UNITED STATES PATENT AND TRADEMARK OFFICE

APPLICATION NO.	FILING DATE	FIRST NAMED INVENTOR	ATTORNEY DOCKET NO.	CONFIRMATION NO.
10/762,526	01/23/2004	Chang Won Choi	2557-000177/US	5346

Office Action Summary	Application No. 10/762,526	Applicant(s) CHOI ET AL.	
	Examiner Jeffrie R. Lund	Art Unit 1792

DETAILED ACTION

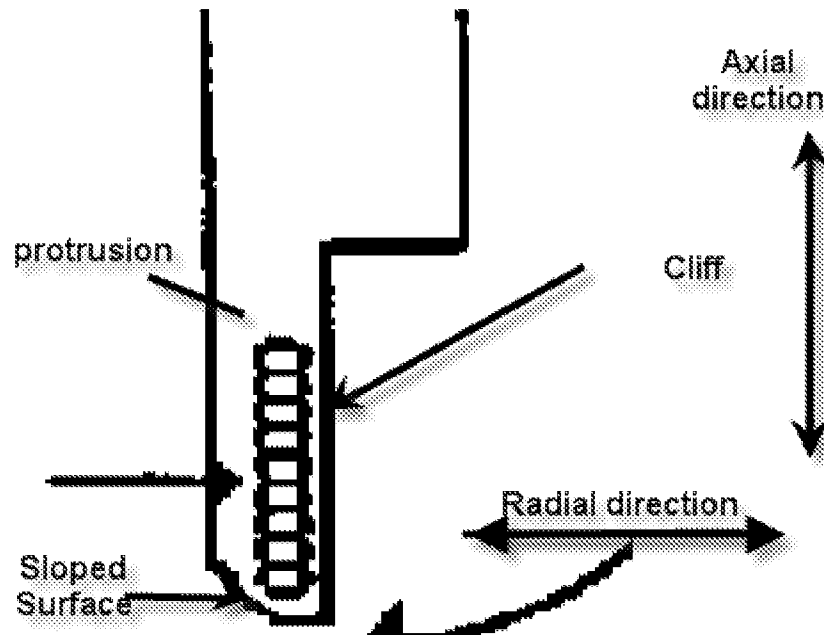
Contrary to the insulating plate of claim 44, however, the protruding portion of the top plate 120 including the top magnetic coil 122 {identified as P1 in the portion of FIG. 1 shown below) does not include any "sloped surface." As noted above, this portion of the top plate 120 extends vertically downward. See, Berman at FIG. 1.

Moreover, the portion of the top plate 120 including the magnetic coil 122 protrudes in a direction perpendicular to a radial direction (also know as axial direction) of the top plate 120, but not "outwardly in a direction parallel to a radial direction," of the top plate 120, as required by claim 44, assuming arguendo that the top plate 120 corresponds to the "body," of claim 44 (which Applicants do not admit)."

- a. Berman et al teaches an electrode 102 surrounding a wafer 104. The plasma is prevented from reaching the center of the substrate by an insulating top plate 120. Thus, Berman et al does teach an insulating plate.
- b. Berman et al teaches a protrusion, including a sloped surface and a cliff surface, the protrusion protruding outwardly in a direction parallel to a radial direction of the body. As can be seen below, the protrusion includes: a cliff, a

sloped surface, and extends in a radial direction.

Thus Berman et al teaches the claimed limitations.
